CAPISTRANO BEACH

WETLANDS DELINEATION

DEPARTMENT OF THE ARMY
LOS ANGELES DISTRICT, CORPS OF ENGINEERS
PO BOX 532711
LOS ANGELES, CALIFORNIA 90053-2325

The purpose of this letter is to respond to your request for information concerning our determination of geographical extent of waters of the United States, located at the 2-acre site known as the Castillo del Mar development, along Camino Capistrano in the community of Capistrano Beach, in the city of Dana Point, Orange County, California.

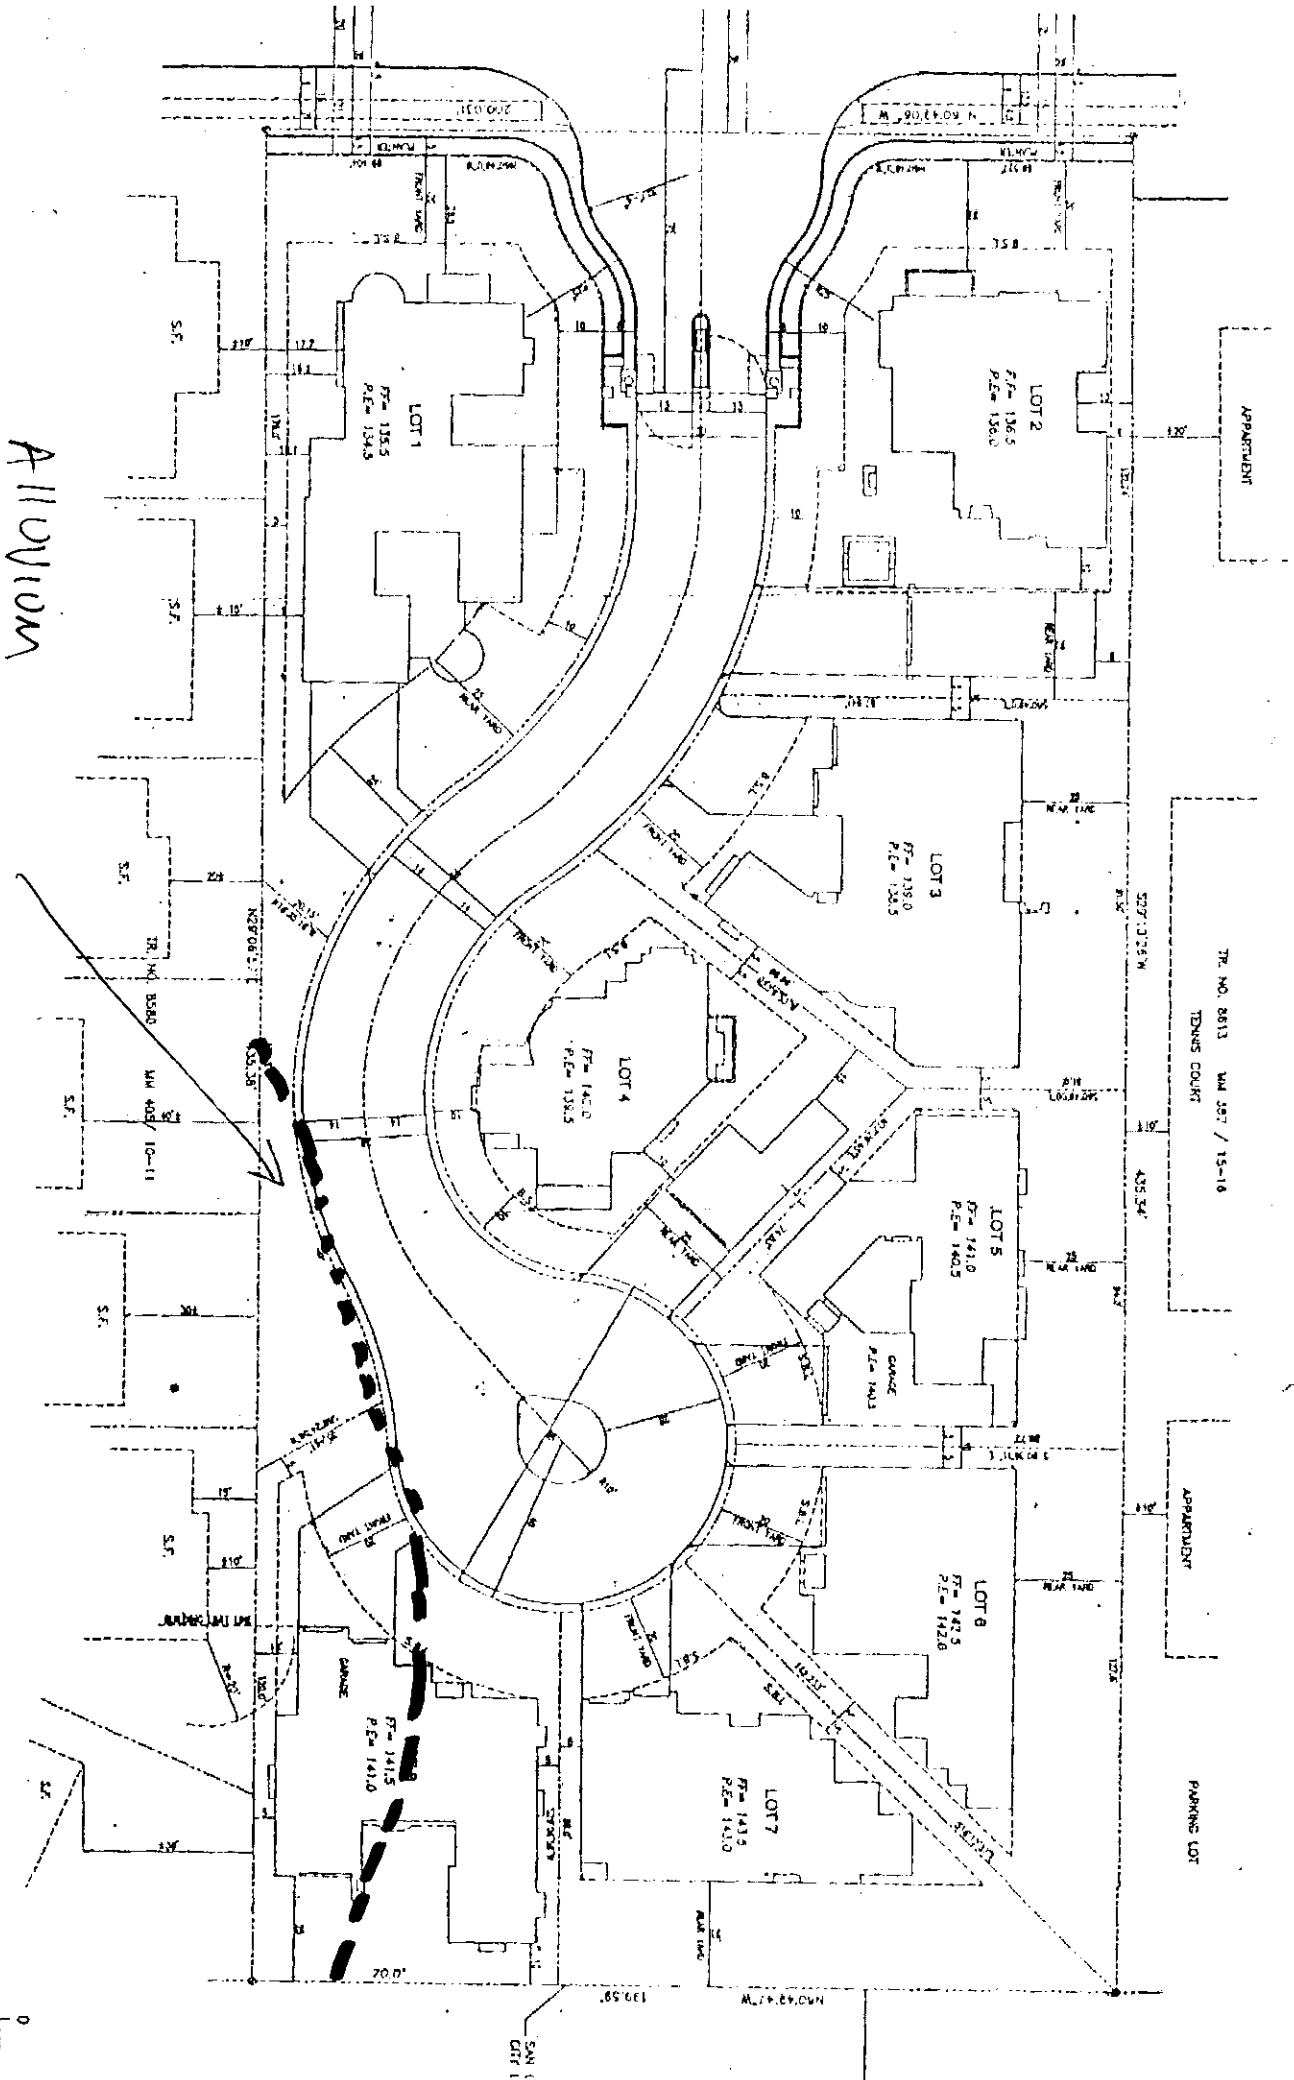
My staff reviewed GLA's sketch and calculated the square footage for each of nine different 20-foot segments (180 linear feet) based on the cross-sectional widths indicated on the drawing. The enclosed diagram (Exhibit 1) shows the calculations made by my staff for each segment. For example, my staff calculated segment 2 to be approximately 430 sf (25' W x 20' L). Additionally, my staff cross-referenced the extent determined from the sketch with the hydrology report (Toal Engineering, 2002) and geology report (Via Geos, 2001). For segment 3, GLA indicated the width of the drainage was approximately 25 feet wide; however, Via Geos dug trench E3 and observed mottled soils (an indicator of hydric soils) at approximately 41 feet from the east property line (Exhibit 2). In the absence of confirmation of sufficient hydrology and hydrophytic vegetation at 41 feet from the fence, my staff calculated the area for segment 3 using both a 25-foot and 40-foot width. Both areas for segment 3 were used to obtain a range for the calculated total area for the entire drainage.

Therefore, based on the diagram and the other supporting documentation, we calculated the range of jurisdictional wetland to be from 0.048 to 0.054 acre, or approximately 0.05-acre area of impact. We determined the required compensatory mitigation for 0.05-acre of impact to wetland waters of the United States to be 0.25 acre (5:1 mitigation ratio) of wetland waters of the United States.

ACTUAL SITE PLAN

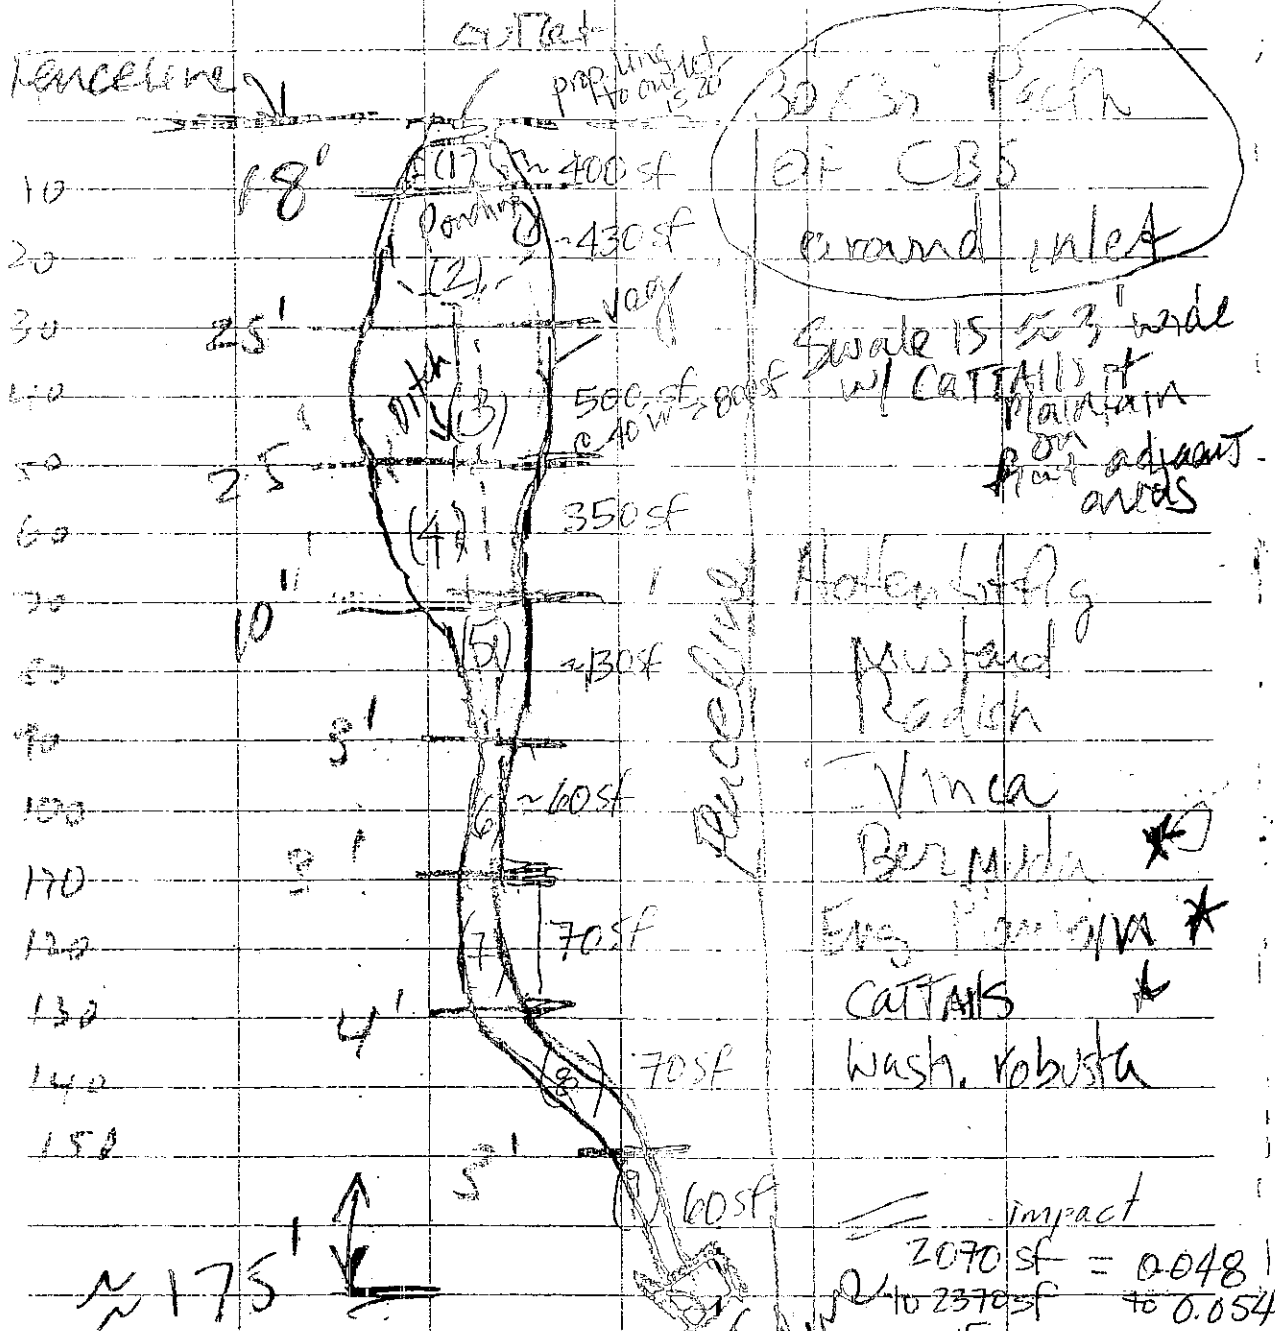
We want to make it very clear that we do not question the credentials of Tony Bomkamp, Biologist, of Glenn Lukos Associates. However, his finds in his report of June 6, 2002 were in error. Mr. Bomkamp did not feel this was a wetlands. Therefore, we feel he did not spend the necessary time to delineate the area properly. His enclosed field drawings appear to be approximations versus accurate measurements.

At the present time the only delineations that were done of the wetlands were by Tony Bomkamp of Glen Lukos associates. The field drawings were crude and not accurate. He guessed at the dimensions.

EXHIBIT 2

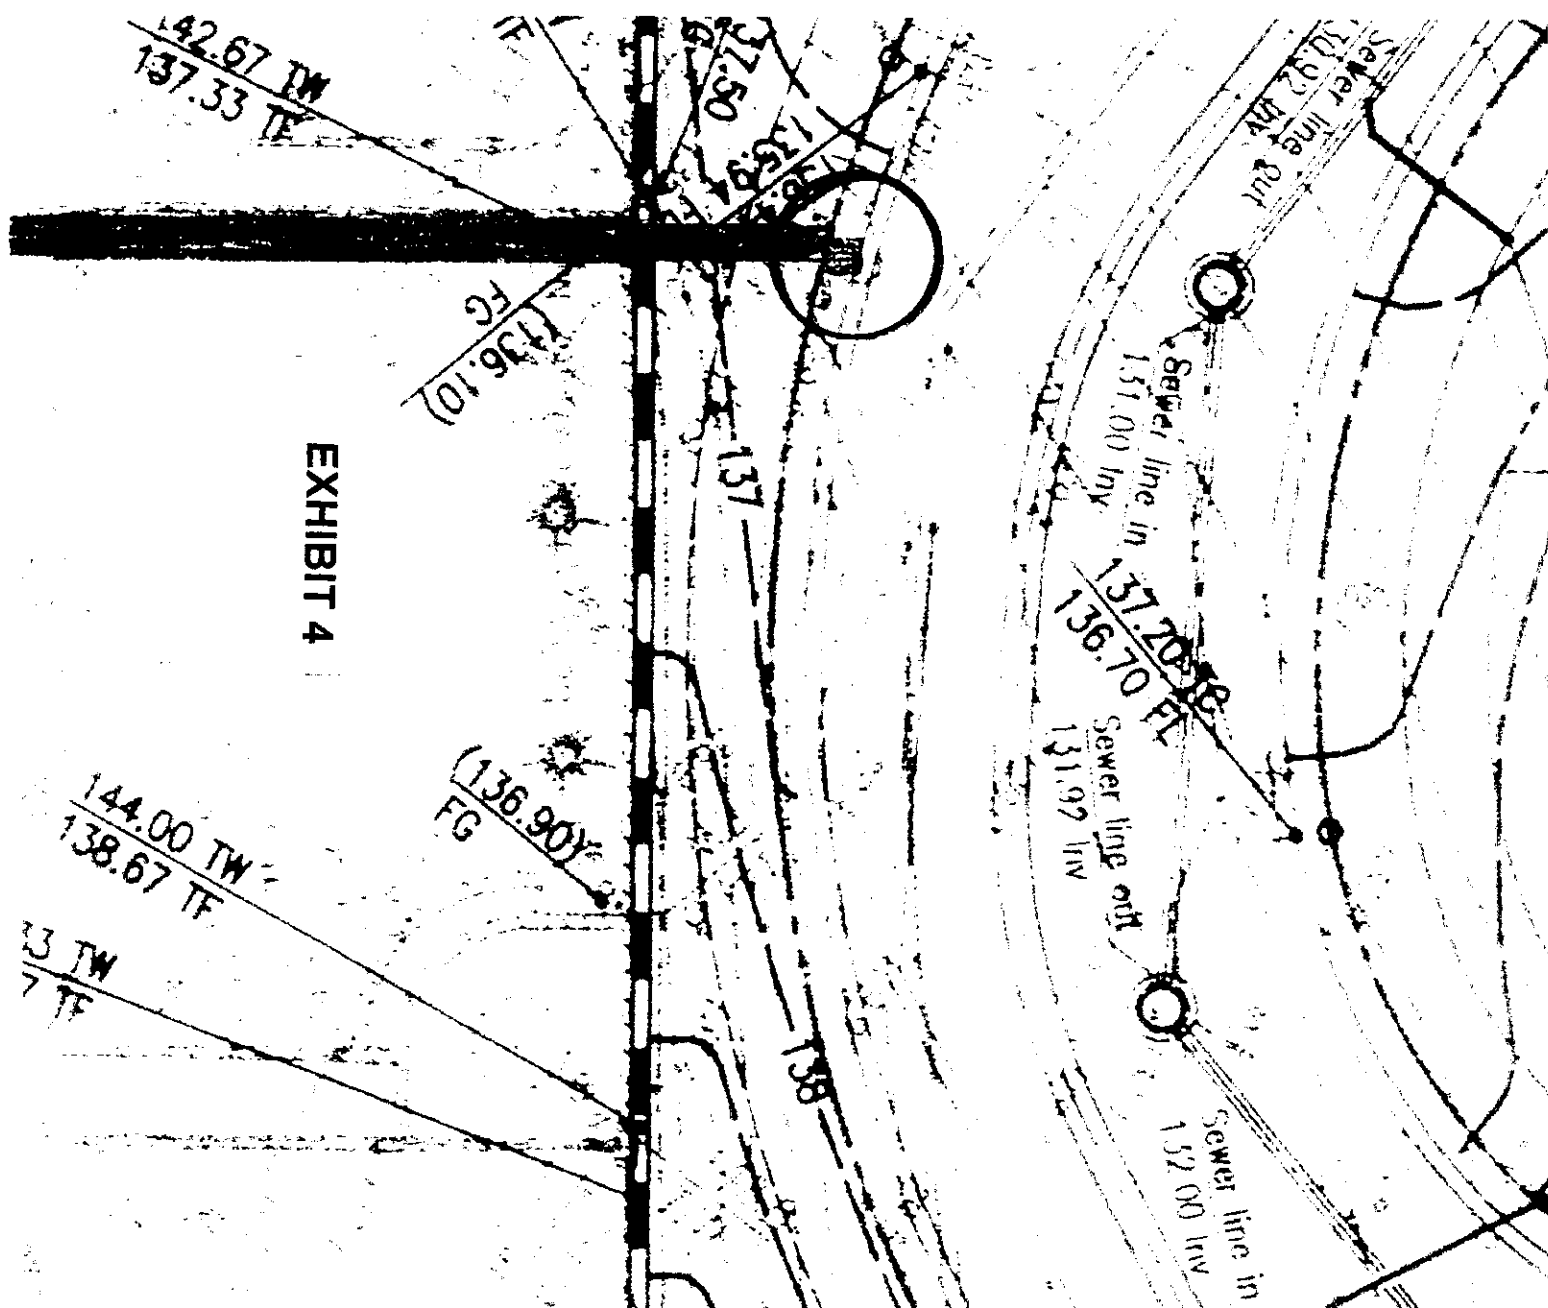
Exhibit 2 - We used Toal Engineering's drawing that were submitted to the City of Dana Point to get the dimensions of the lot. The actual length of the wetlands is 235 feet not the 175 feet that Tony Bomkamp has listed.

EXHIBIT 6

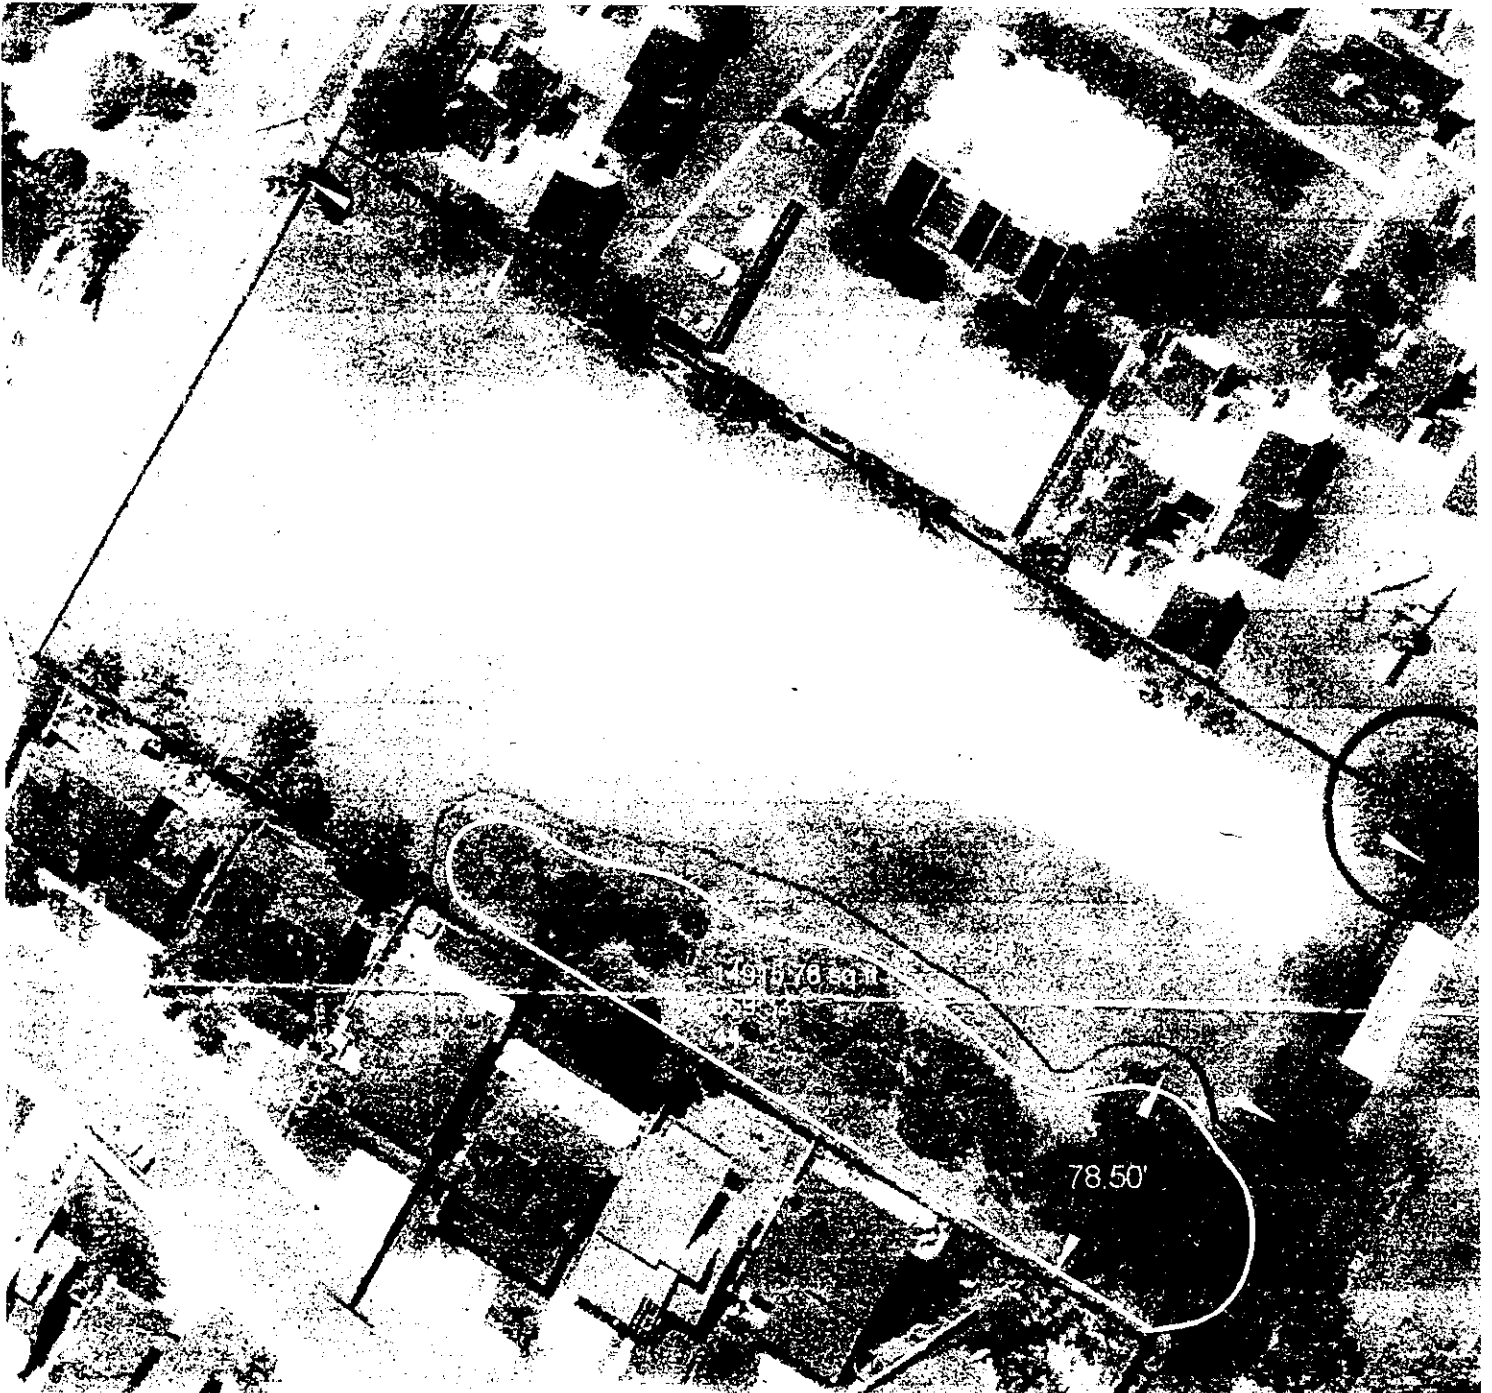
Attached are calculations regarding the size of the wetlands in Capistrano Beach. Toal Engineering's Plans were used to denote the actual length and width of the Pioneer project. We have calculated the square footage of the actual wetlands using AutoDesk QuickCAD 8. The red line is just the outline of the wetlands. The yellow line which follows the tree line and vegetation line was used to calculate the size.

14,915.78 Square Feet

.342 of an Acre

Mitigation at a 5:1 ration = Total of 1.712 Acres

Although the aerial photographs provide an indication that vegetation was present prior to grubbing, the aerial and pre-disturbance photos indicate much of the width of the vegetated area was comprised of upland species, e.g., coyote bush scrub. As I explained in our previous telephone and email conversations, the method you used to estimate the 0.342-acre area is an expansive method, which includes non-Corps jurisdictional areas.
